**From:** Nicole Horvitz  
**Sent:** Wednesday, November 05, 2014 9:49 AM  
**To:** jima.pc@gmail.com; jitze@couperus.org; jsmandle@hotmail.com; kavitat@comcast.net; richard.partridge@comcast.net  
**Cc:** Roger Spreen; Suzanne Avila; Jaime McAvoy  
**Subject:** Proposed Fence at 26520 Purissima Road (lands of Vahdat) Item 3.1  
**Attachments:** Decorative Metal Fence.pdf

## 6 FT. DECORATIVE METAL PICKET FENCE

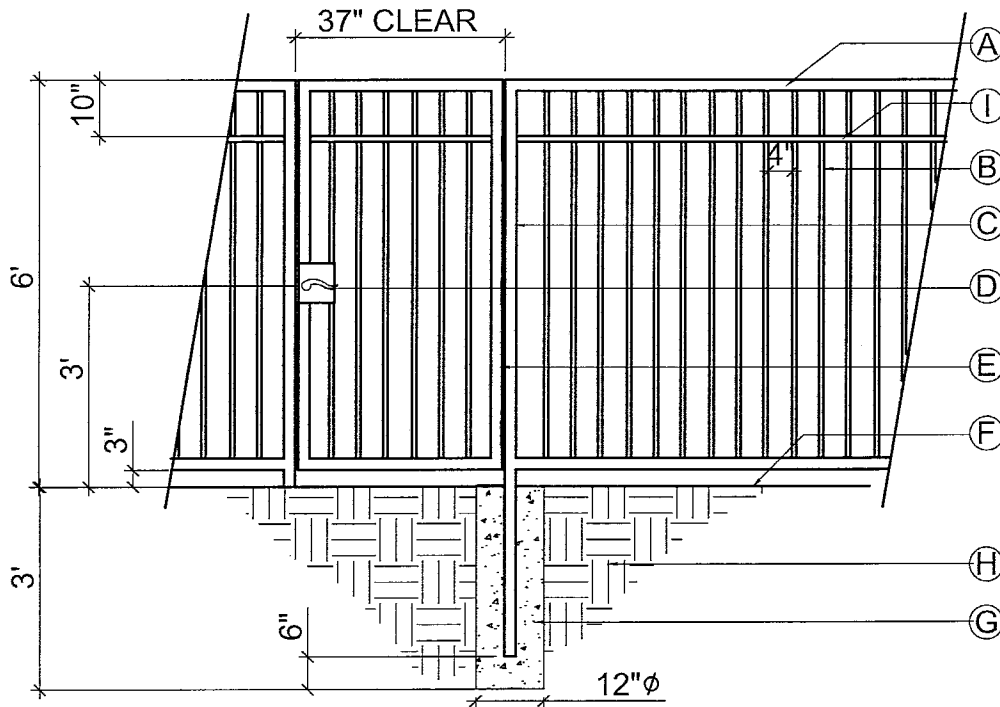
Due to concerns with the proposed fence design (squared top on the wrought iron fence, details on sheet L-4 in your set of plans) for the upcoming landscape screening application, the applicant has revised the design (please see attached) to include a cross bar on the top of the fence. I will note this at the hearing and modify the conditions of approval for your review.
